# 10 LTR PAINT IML CUTTER PROFILE

Itemref	Quantity	Title/Name, designation, material, dimension etc	Article No./Reference		
Designed by FC	Checked by LDEJ	Approved by - date FC - 08/05/13	Filename 10 LTR IML	Date 24/02/15	Scale 1:1
<b>10 LTR PAINT CUTTER PROFILE</b>					
336			Edition D	Sheet 1/1

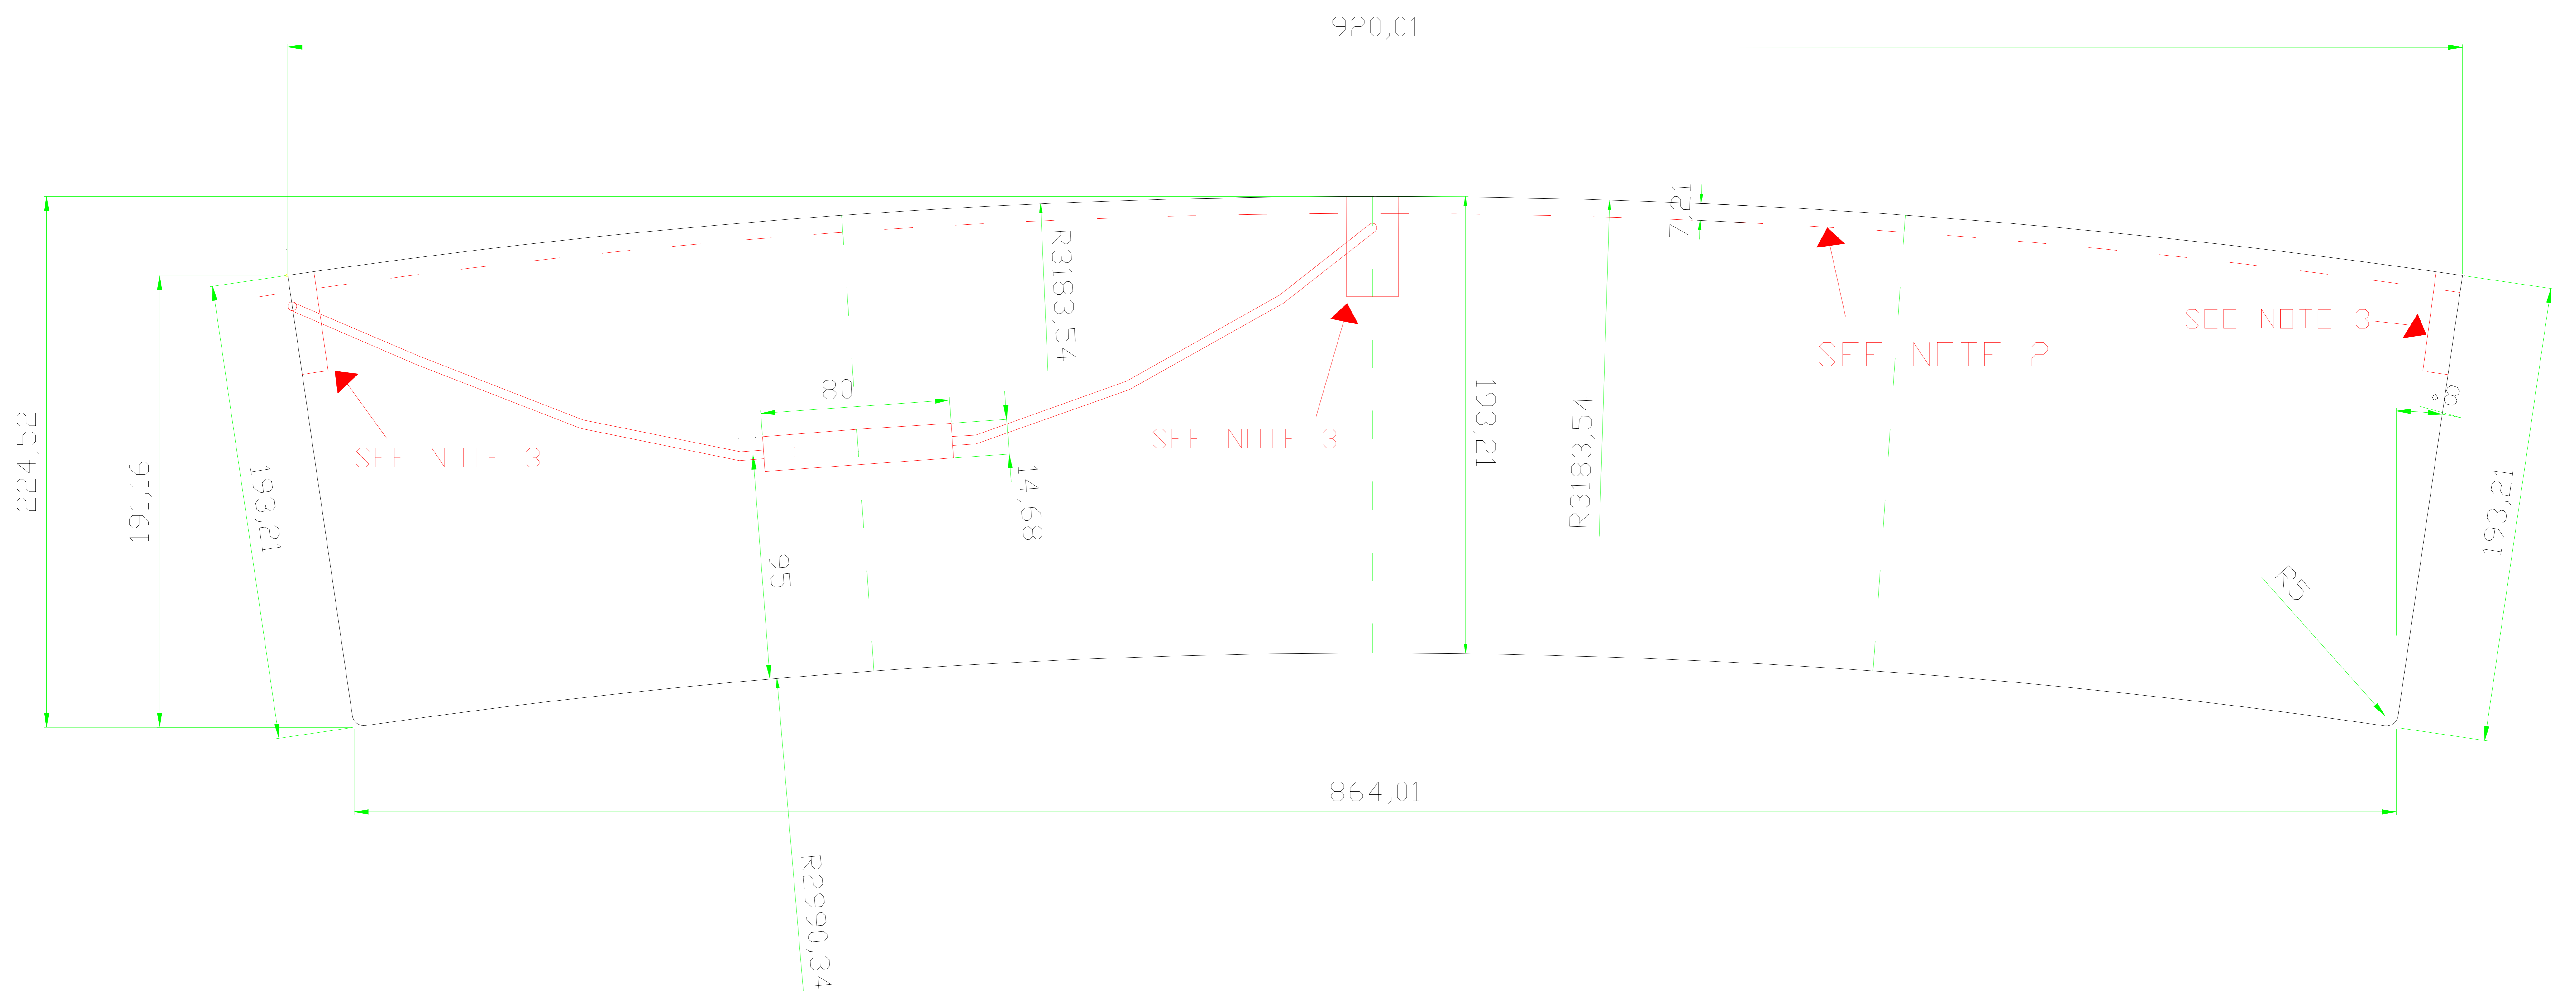
RevNo	Revision note	Date	Signature	Checked
A	Initial Release	17/01/08		
B	DIM E5 CHANGE FROM 82.2 TO 90.2 FROM HANDLE SUPPLIER CHANGE	19/05/09	FC	
C	Reduce Length of Profile by 1MM to 920mm, overlap issues in tool	08/05/13	FC	
D	Reduce Lid Overhang line 1351 to 721 to correct error see note3. Add Handle locators see note3. Slight amend to handle grip position having seen by the	24/02/14	FC
